**ADDENDUM #2**

To: All Bidders  
Project Name: Renovations to:  
GVSD District Administration Office  
100 Lindenwood Drive, Malvern, PA 19355  
Prepared for: Great Valley School District  
301 Lindenwood Drive  
Malvern, PA 19355  
Date: January 11, 2023

Notice to all Contractors bidding the Renovations to the GVSD District Administration Office. This Addendum is to amend or clarify the Contract documents as follows:

**1 | FIRST FLOOR PLAN - DRAINAGE & VENT**

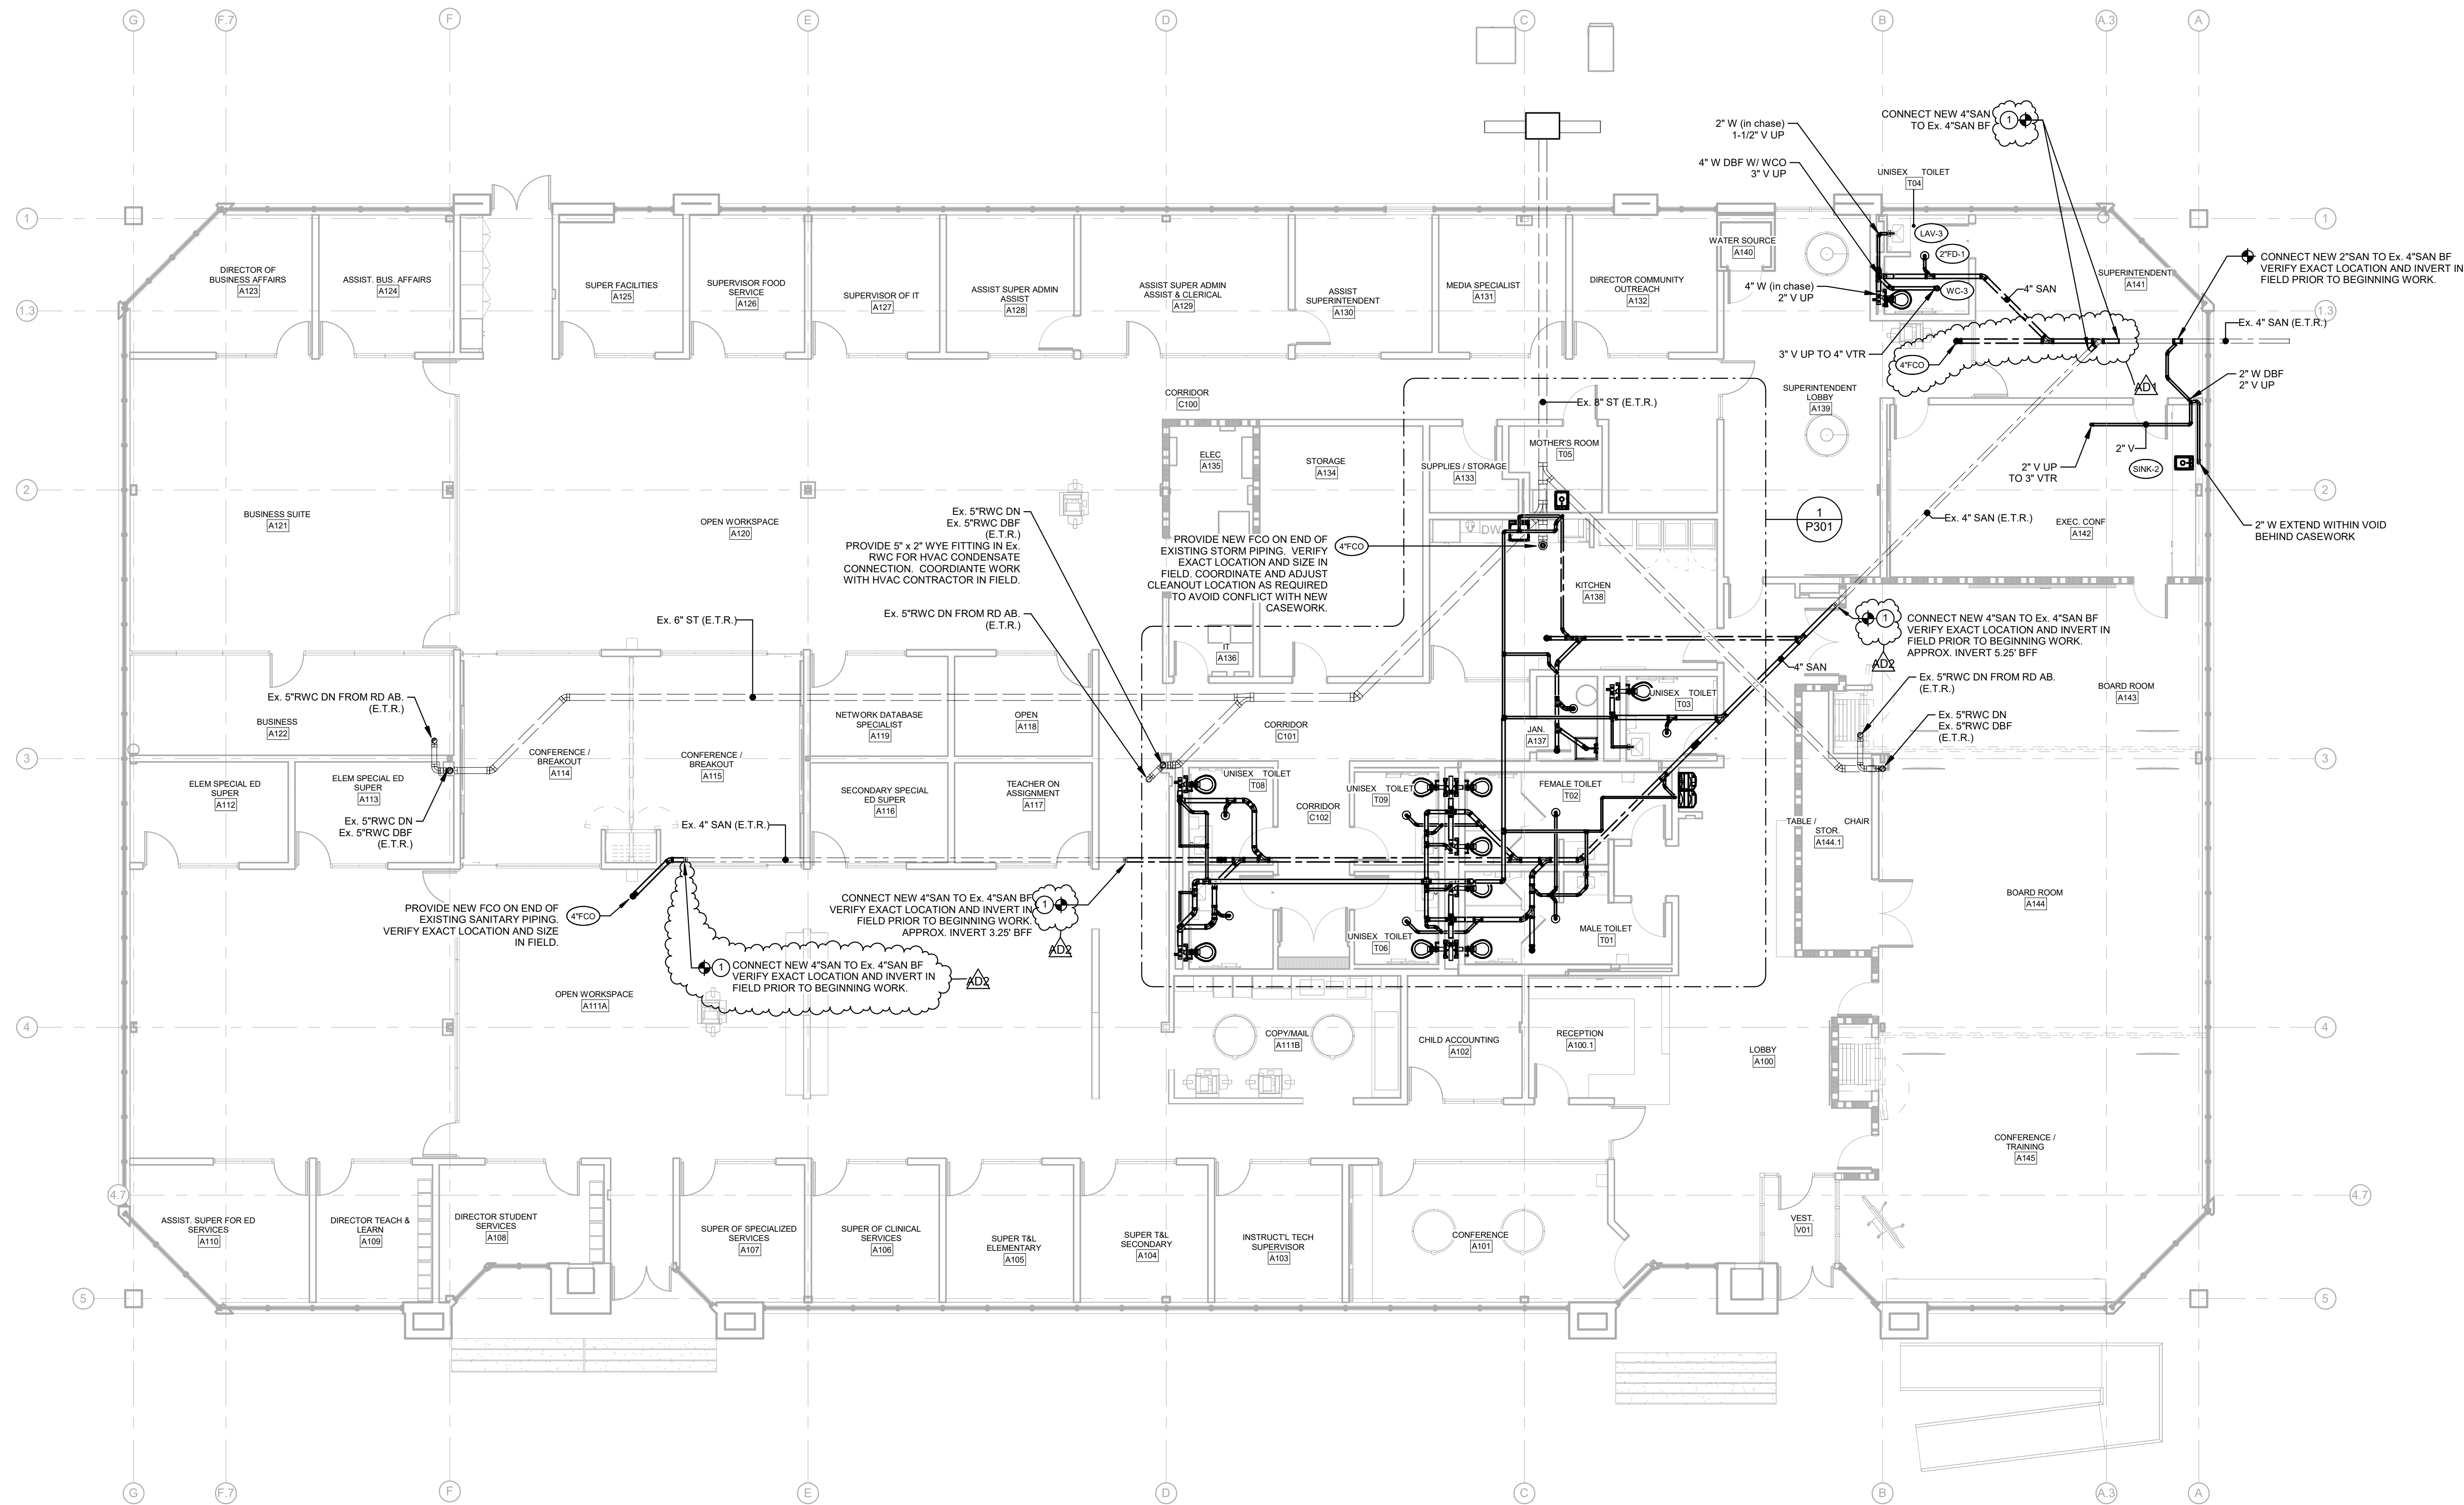
- 2.12 Drawing P101: **CLARIFICATION** Existing Sanitary piping below slab is cast iron. **ADD** drawing note 1 as follows: "Contractor shall provide *approved* fitting for connection of new PVC piping to existing cast iron piping. Verify size and location in field"
- 2.13 Drawing P301: **MODIFY** location of Sink-1 In Kitchen A138 and Sink-3 in Mothers Room T05. Adjust associated supply, drain, and vent piping to new locations. Final connection of dishwasher in Kitchen A138 to supply and drain piping of Sink-1 and all required fittings shall be by P.C.

**1 LOBBY - PARTIAL E. ELEV**

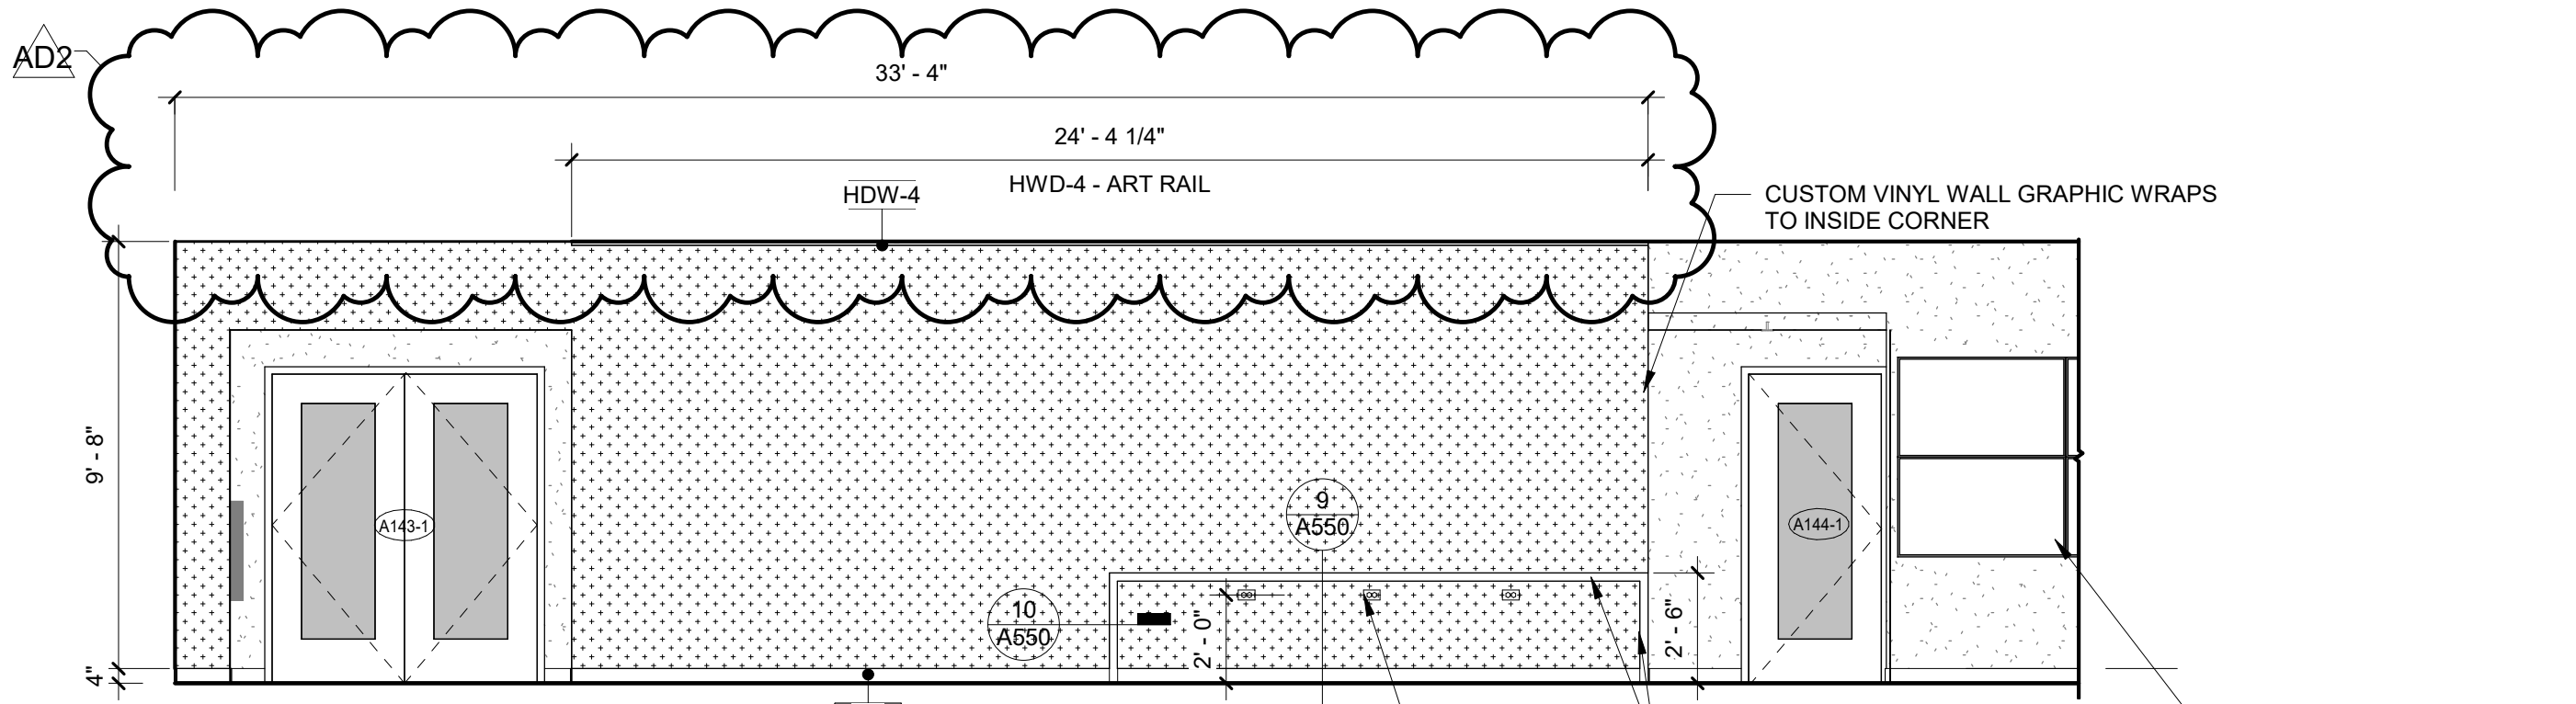
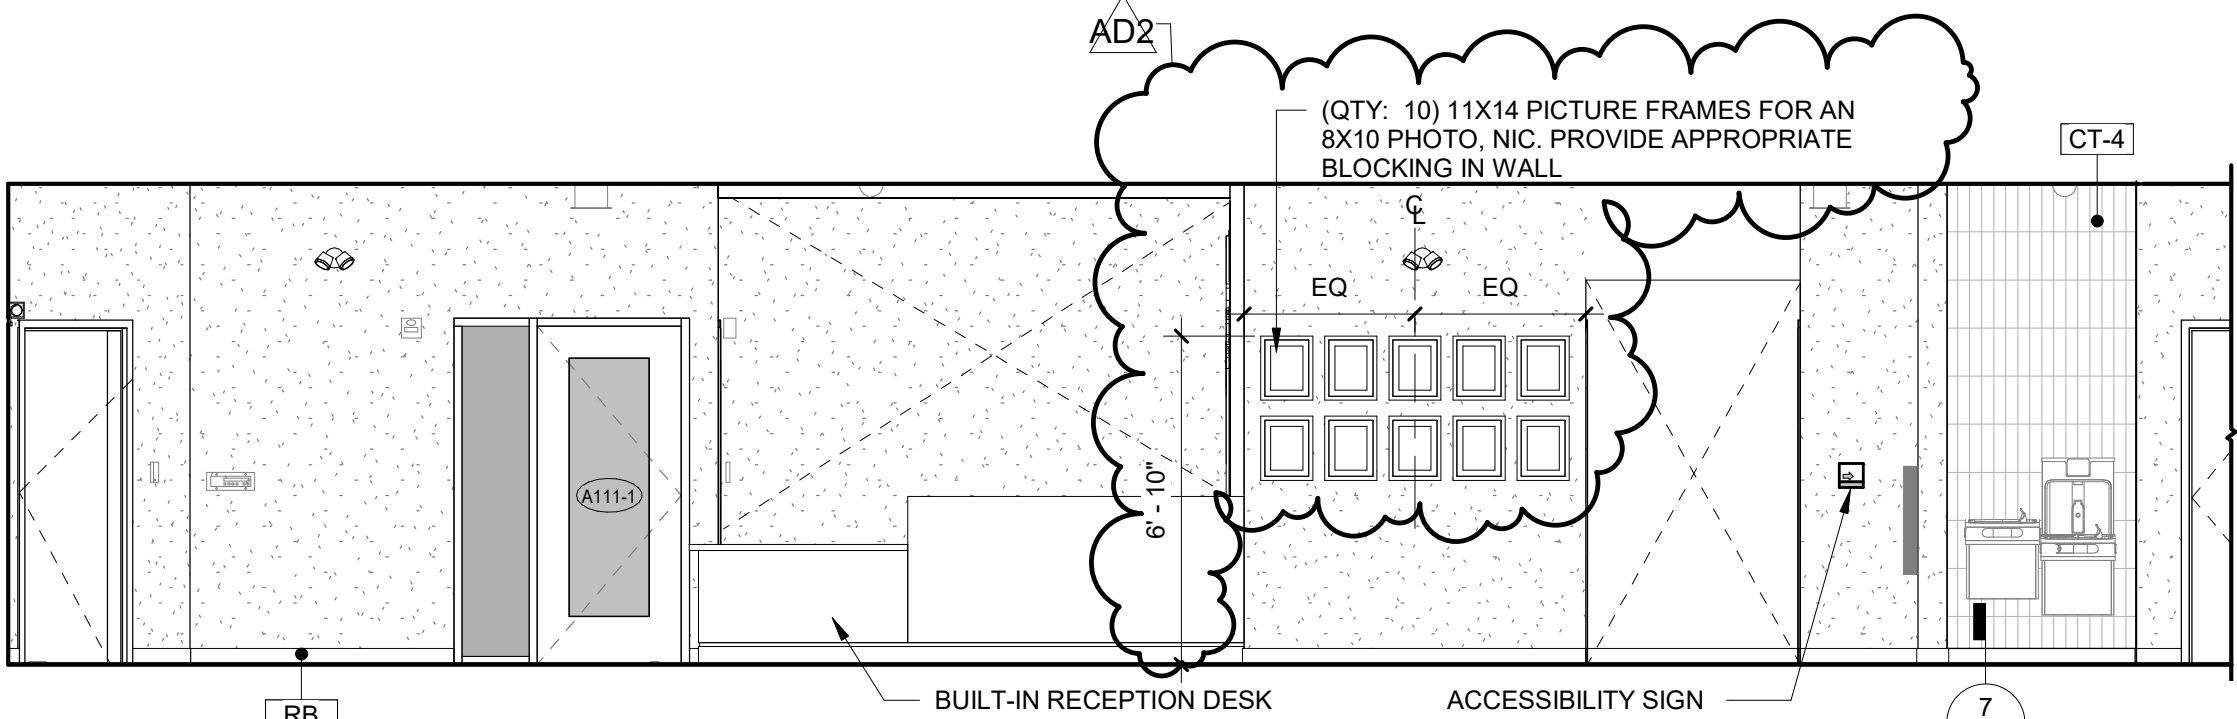
- 2.04 Drawing A806: **MODIFY** open casework shown on elevation 8/A806 to be closed casework with doors as shown on sketch AD2-A02.
- 2.05 Drawing A810: **PROVIDE** Art Rail as noted in item 2.07 on east elevation of Lobby as shown in sketch 1/AD2-A01 and **PROVIDE** blocking as required in west elevation wall as shown in 2/AD2-A01.

# QUESTION 3.013 FROM BIDDER

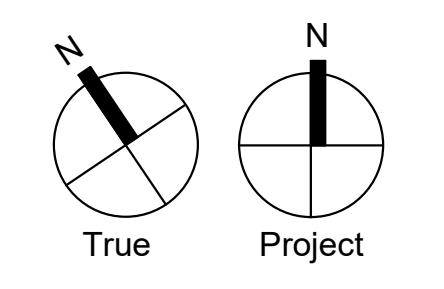
3.013 **Question:** Please see the attached drawing and Identify the Duct Insulation required in the (8) eight highlighted areas in question. (Drawing attached as part of Addendum).

**Response:** *See revised M100, attached as part of this addendum.*
